# LACHLAN'S LINE LOT 110

## RESIDENTIAL APARTMENT BUILDING DEVELOPMENT APPLICATION - ALTERATIONS & ADDITIONS

5 HALIFAX STREET,  
MACQUARIE PARK

1 BUILDING 1 SOUTH FACADE

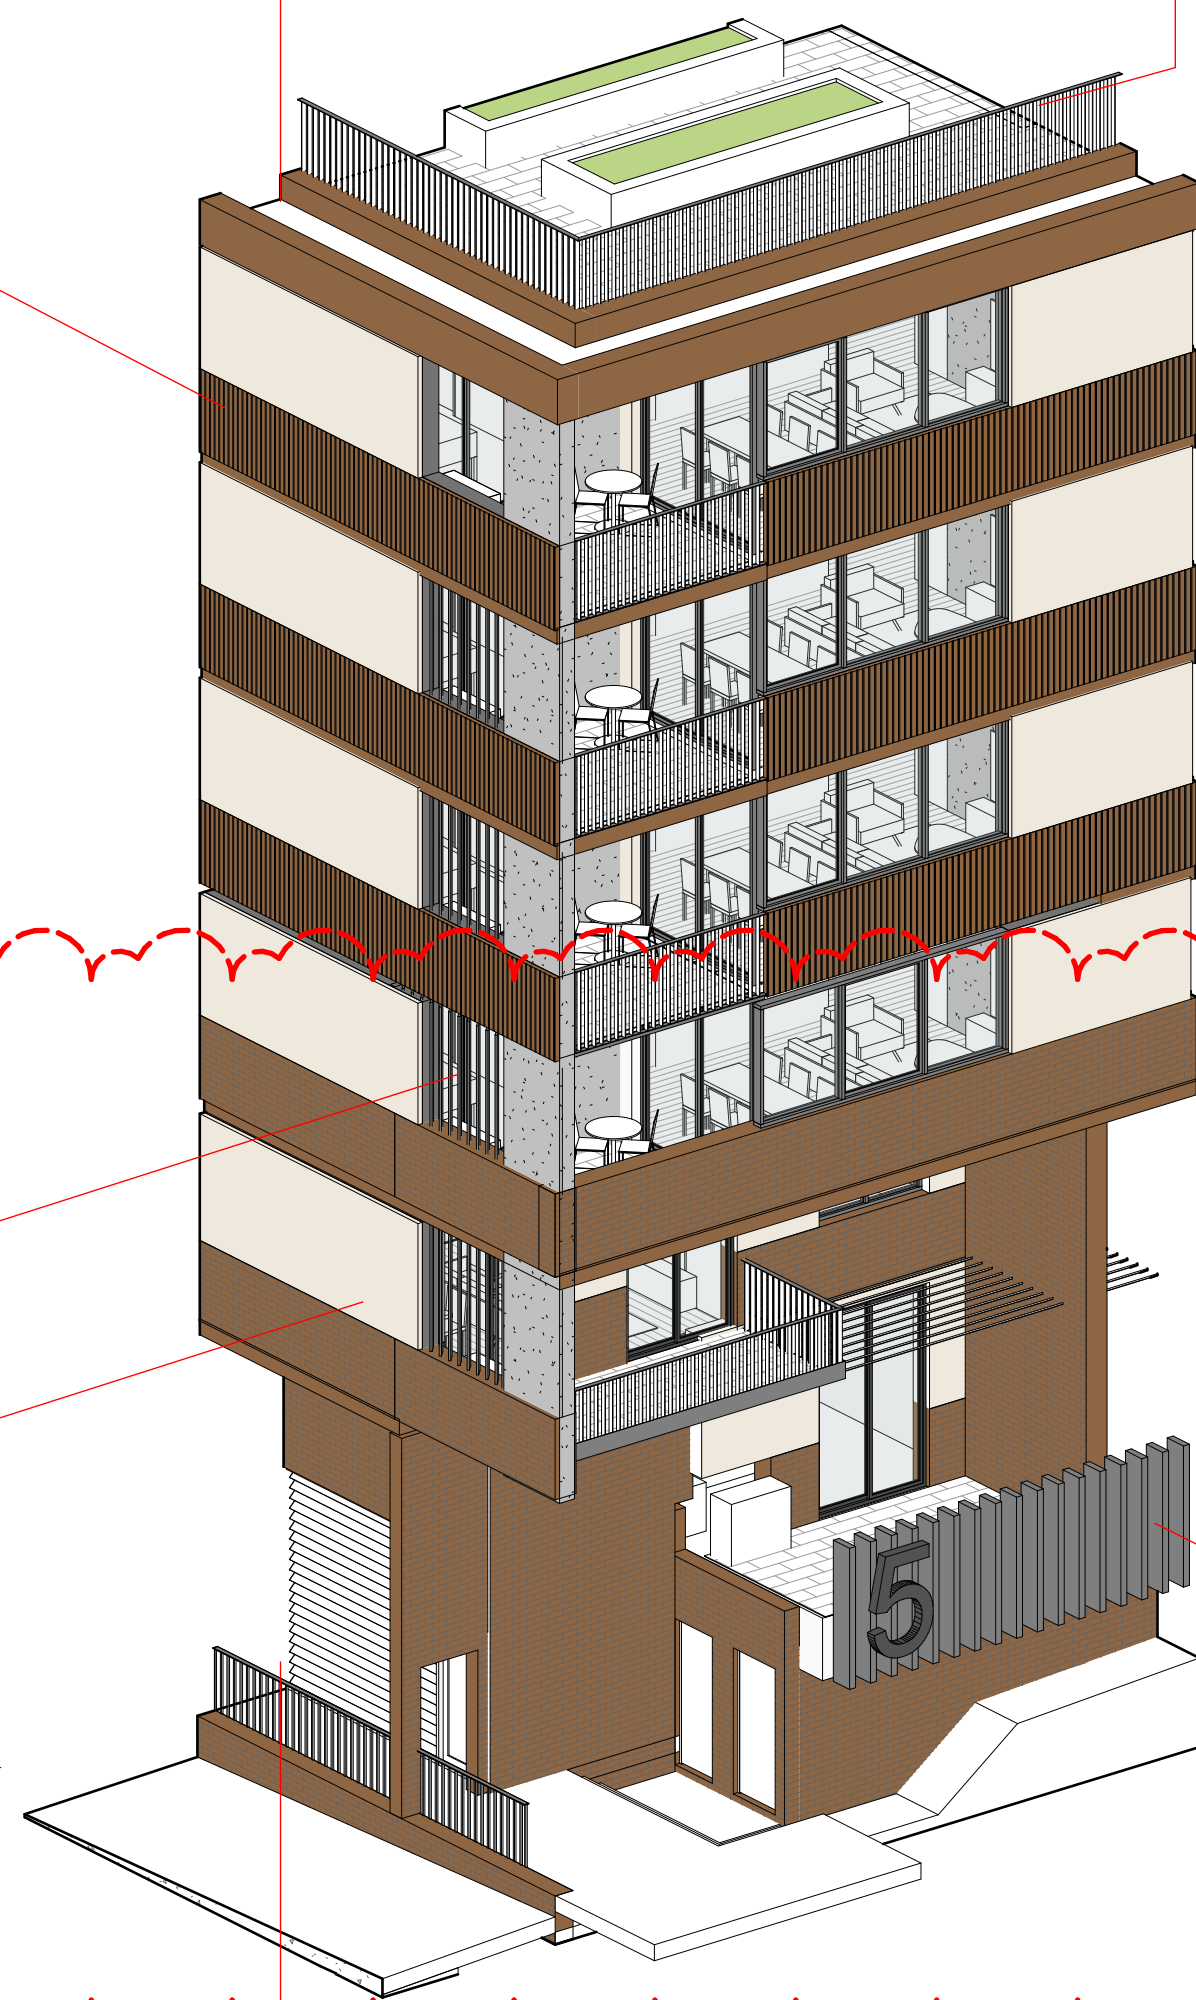
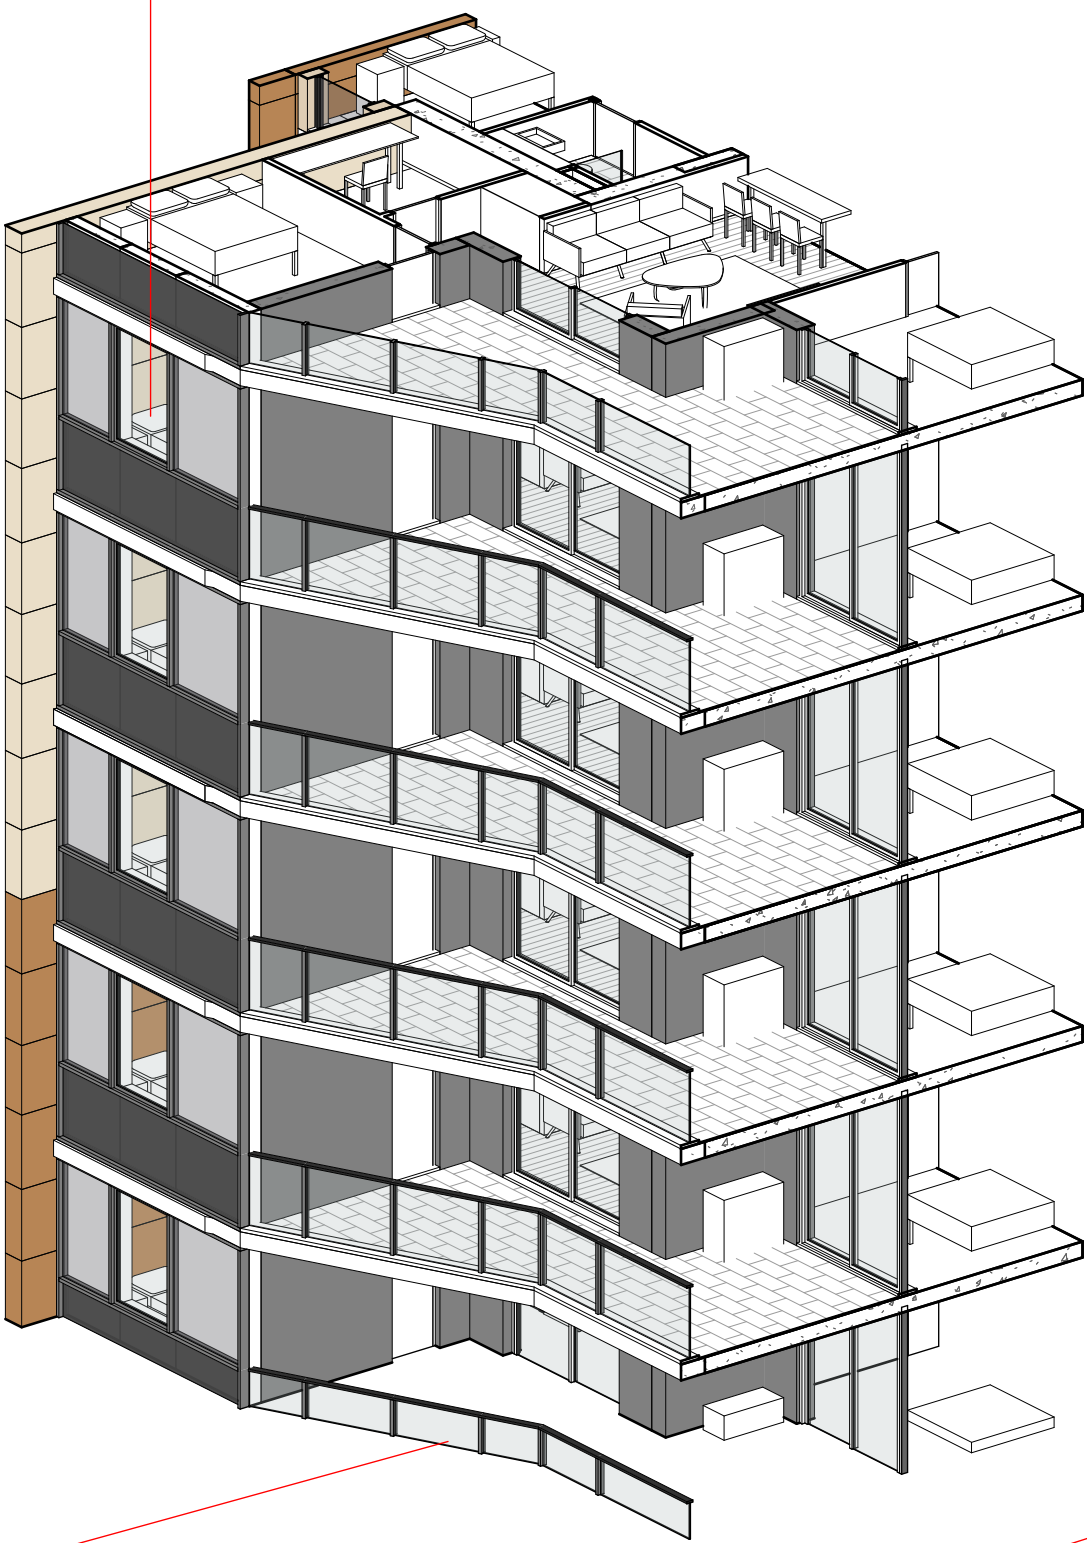
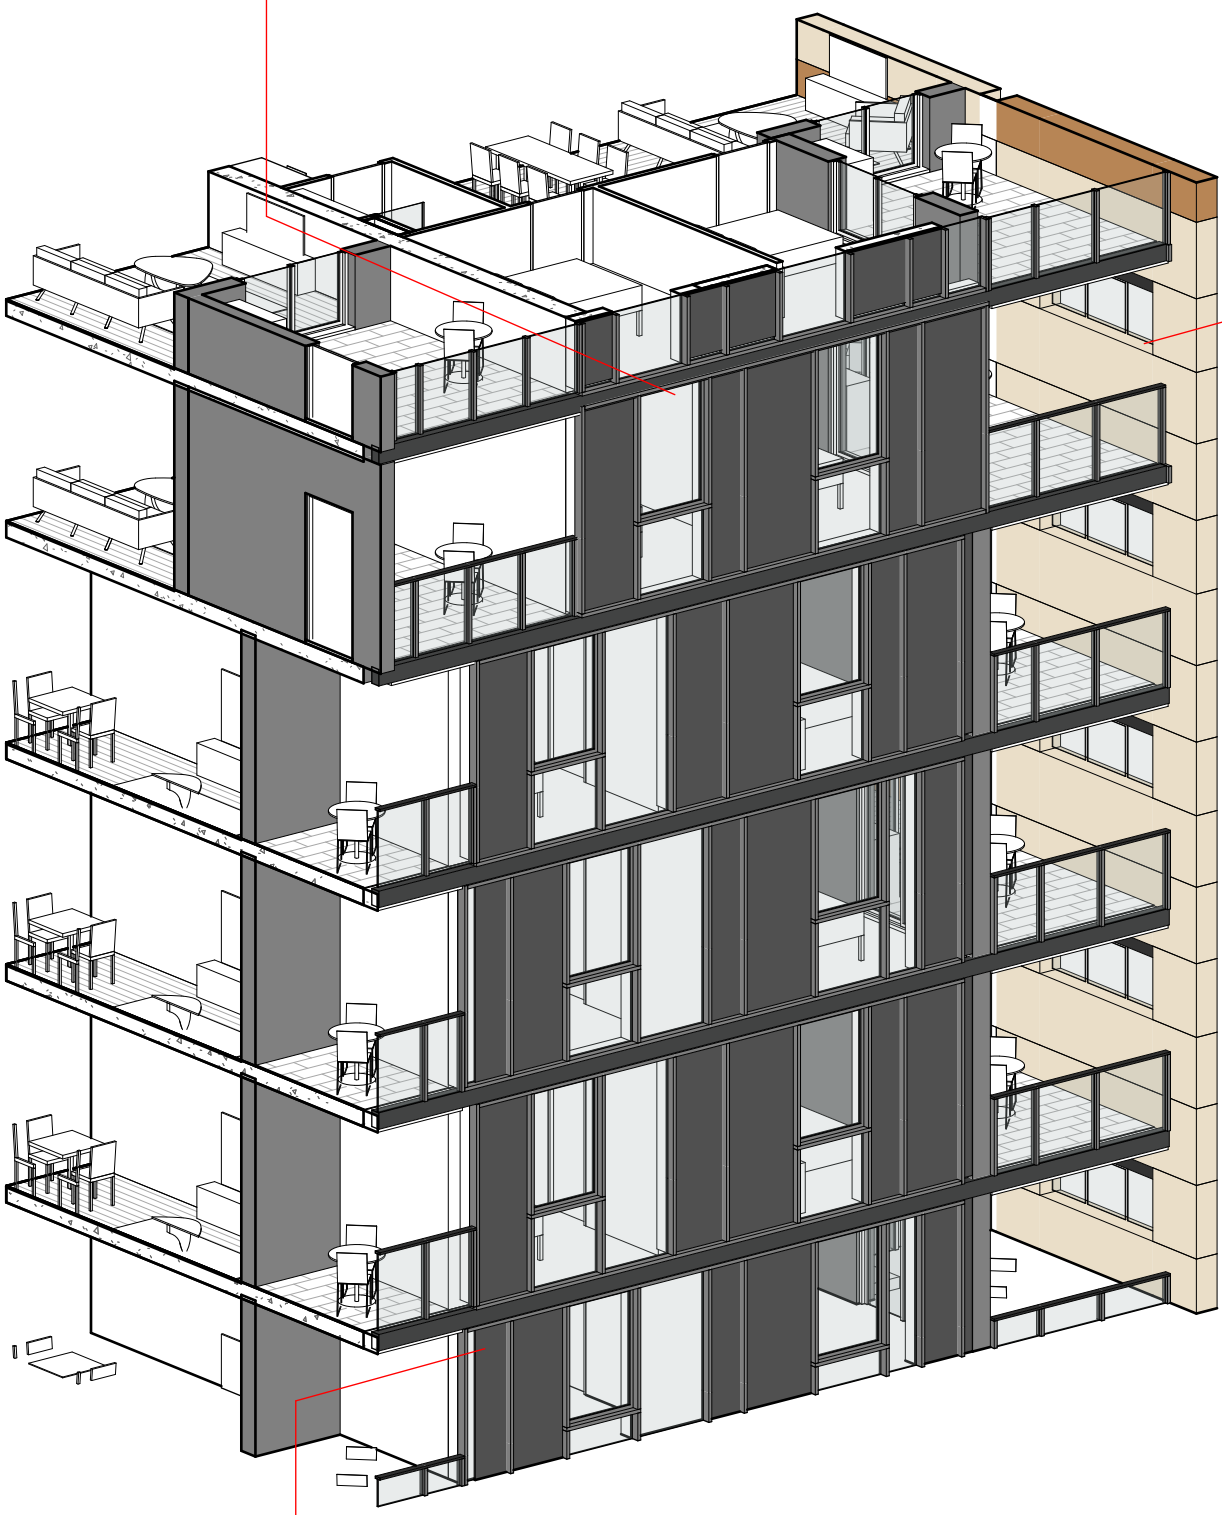
△ E  
FACADE REVISED

3 FSR ANALYSIS

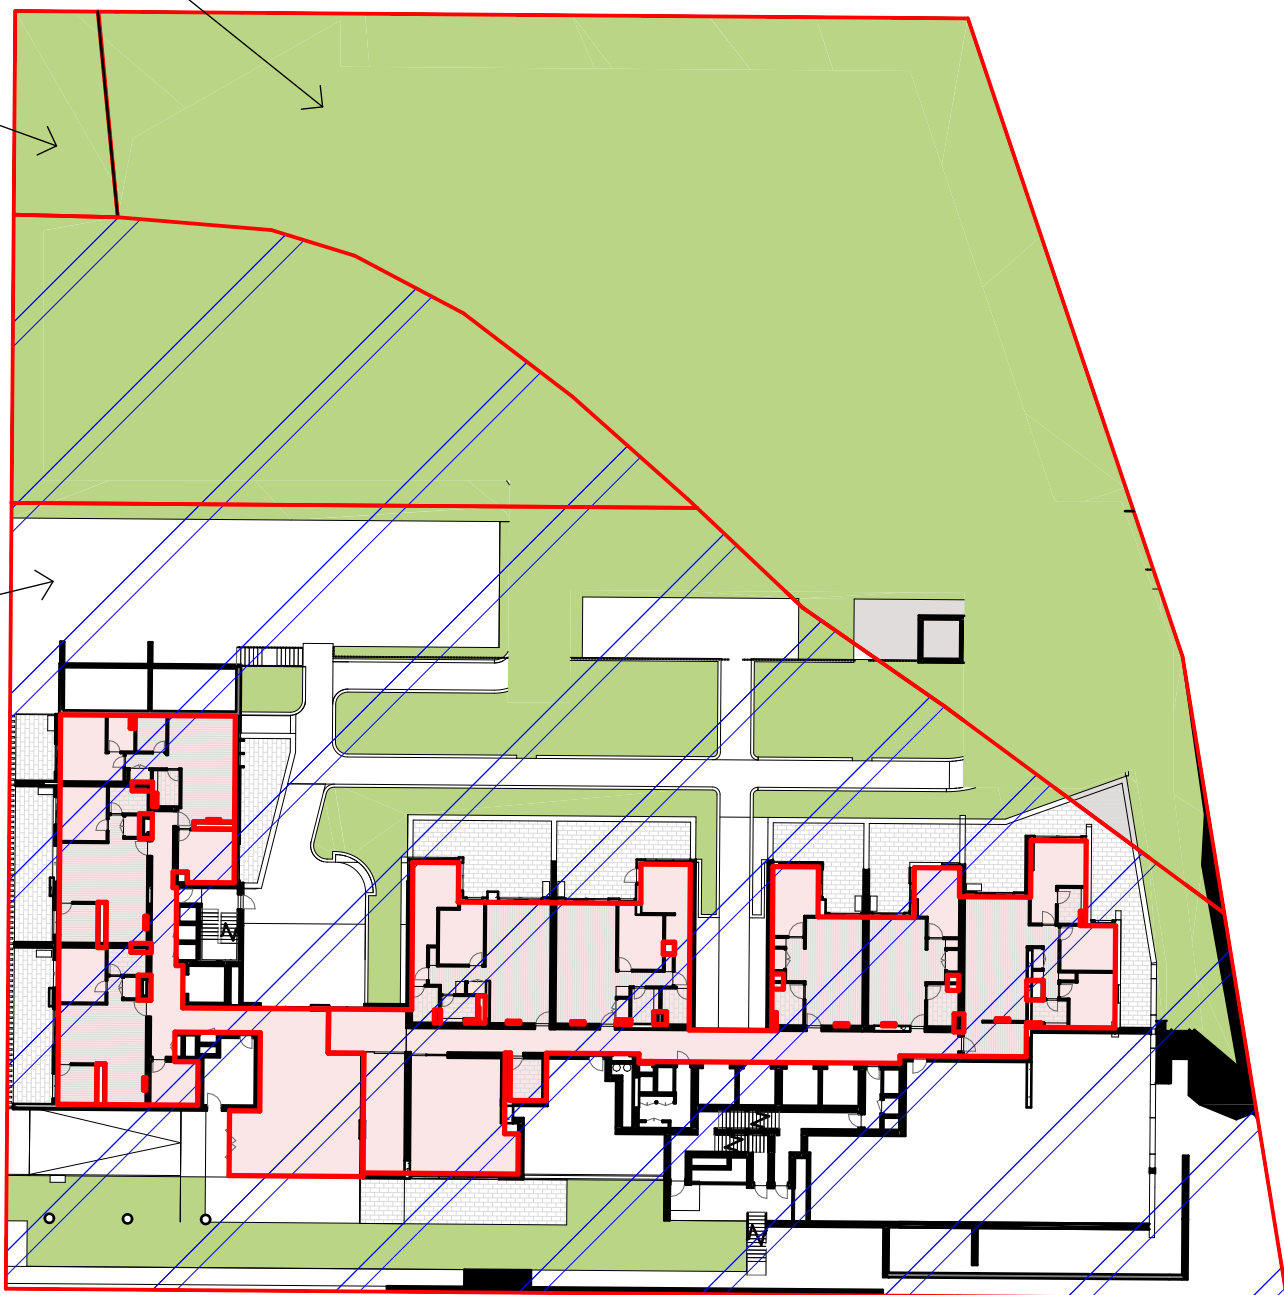
DIAGRAMS AND  
CALCULATIONS REVISED

TEXT REVISED

**SHEET TITLE**  
HEIGHT PLANE  
DIAGRAM

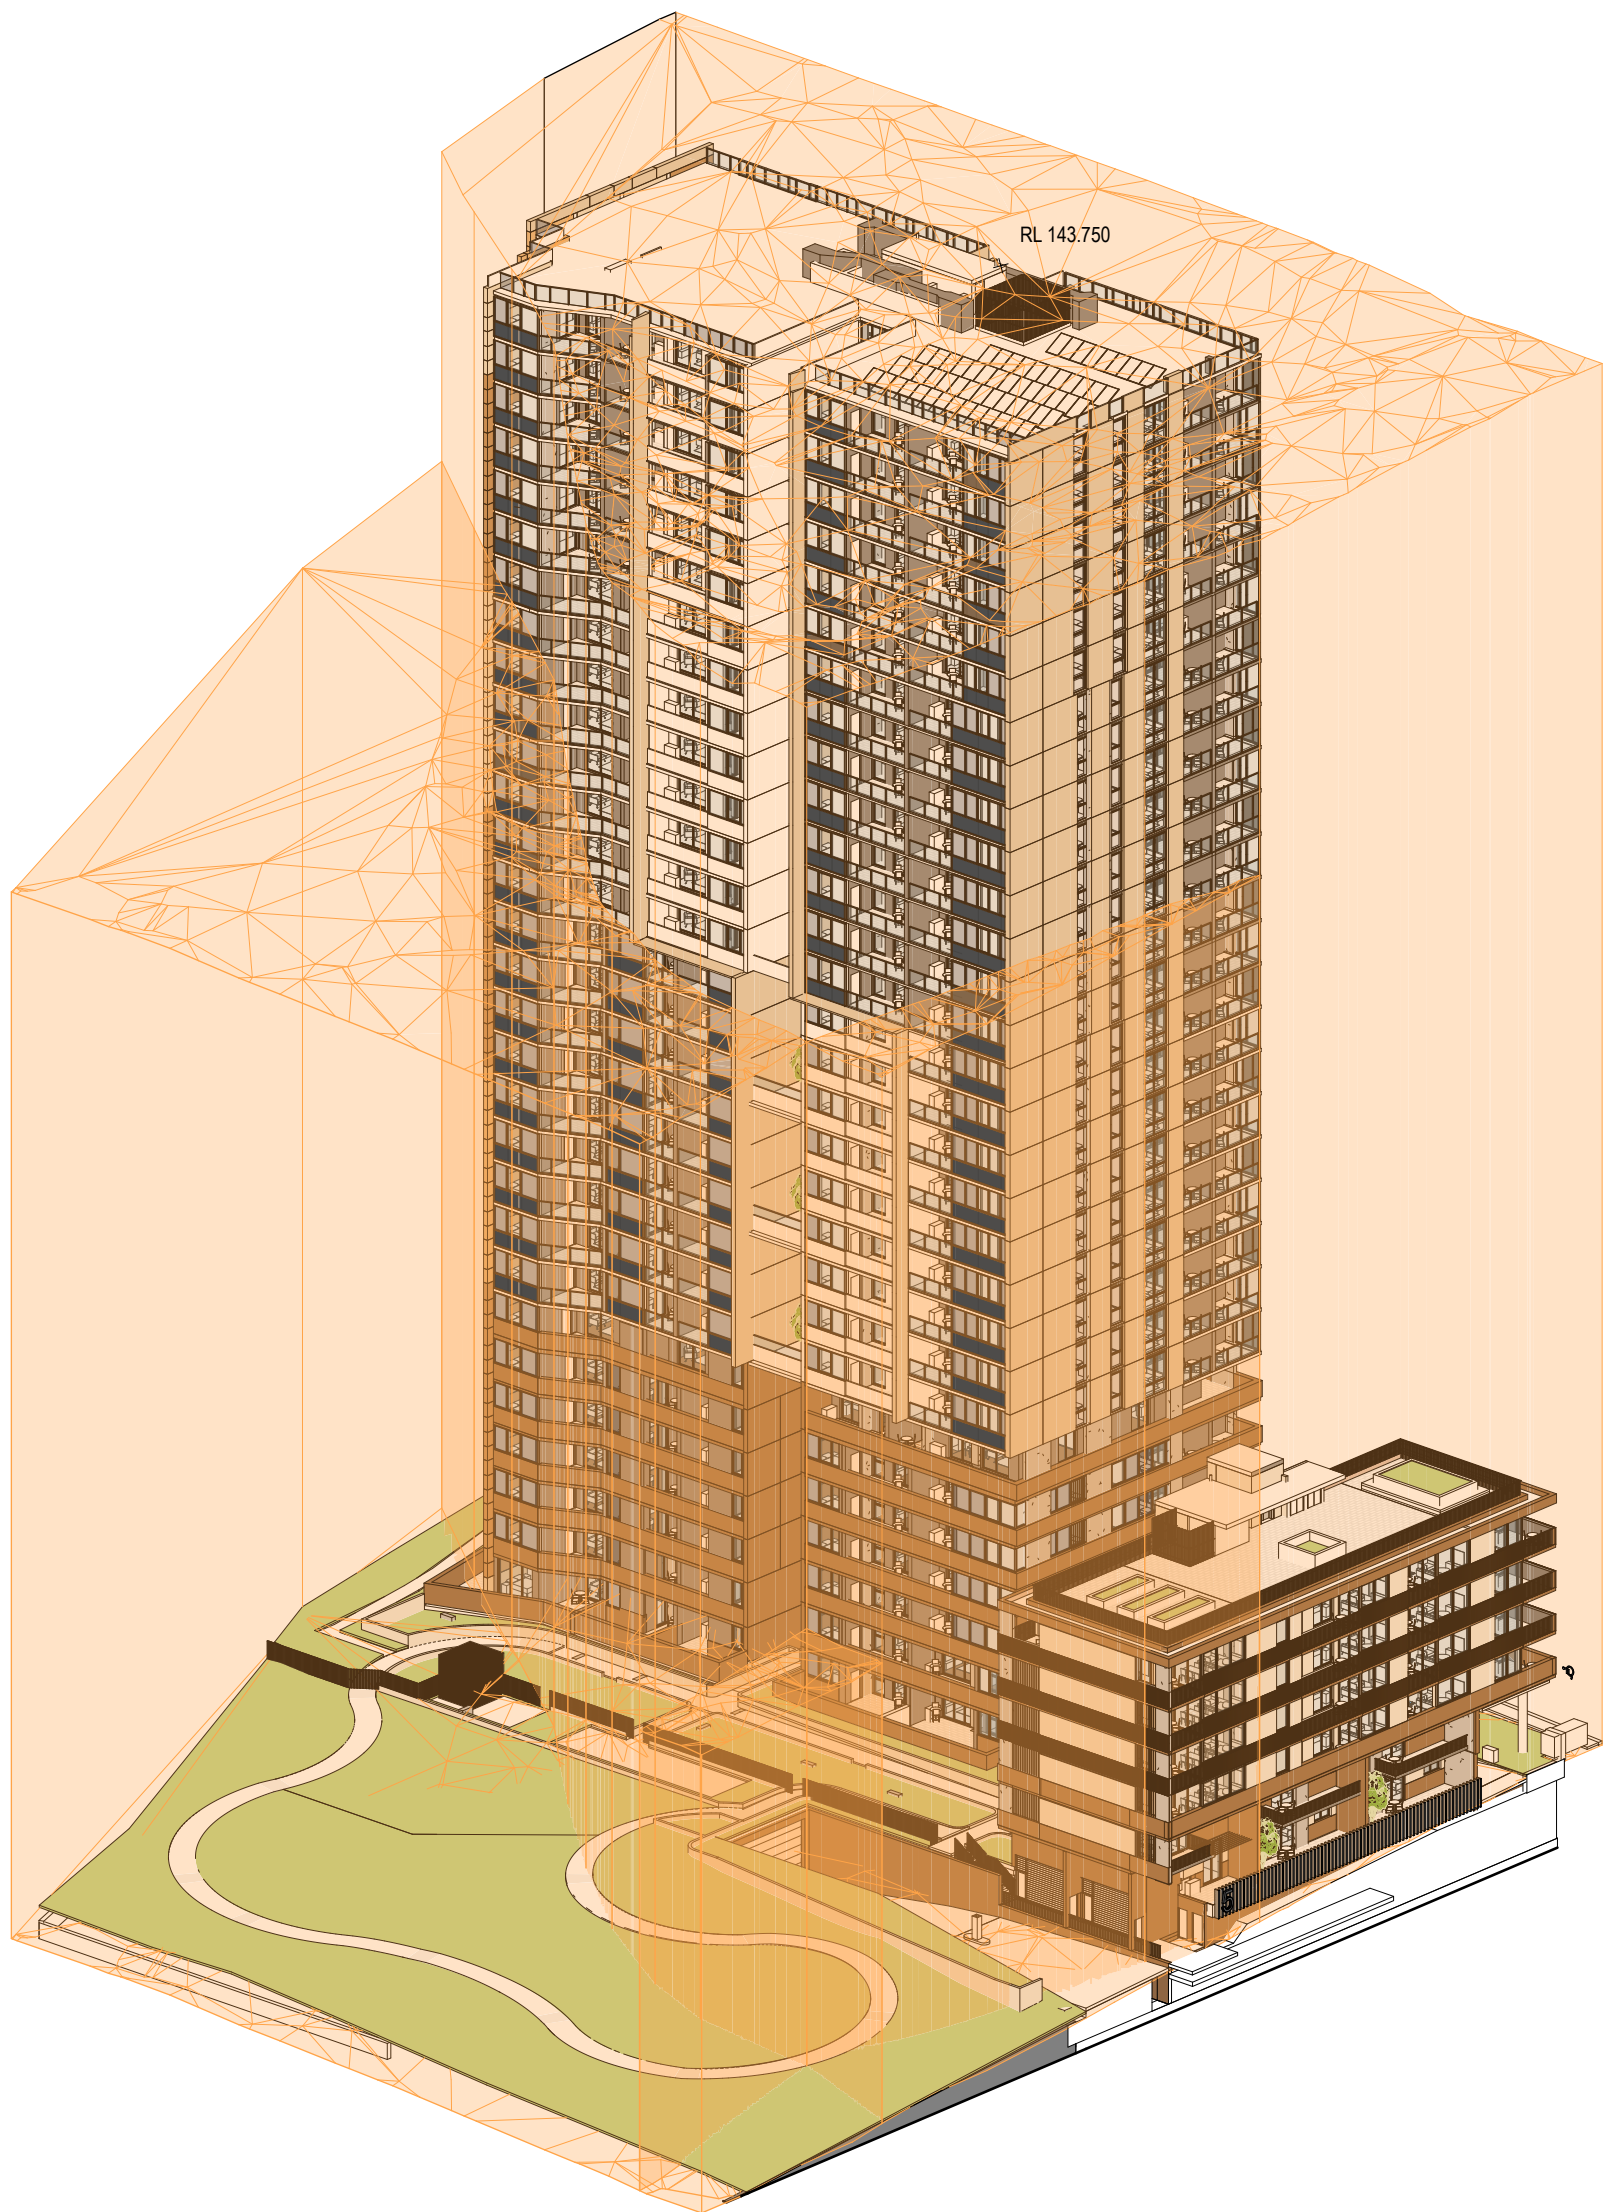
⚠  
BUILDING 3 DELETED;  
BUILDING 1 HEIGHT  
INCREASED (ALL  
BUILDINGS REMAIN BELOW  
HEIGHT PLANE)
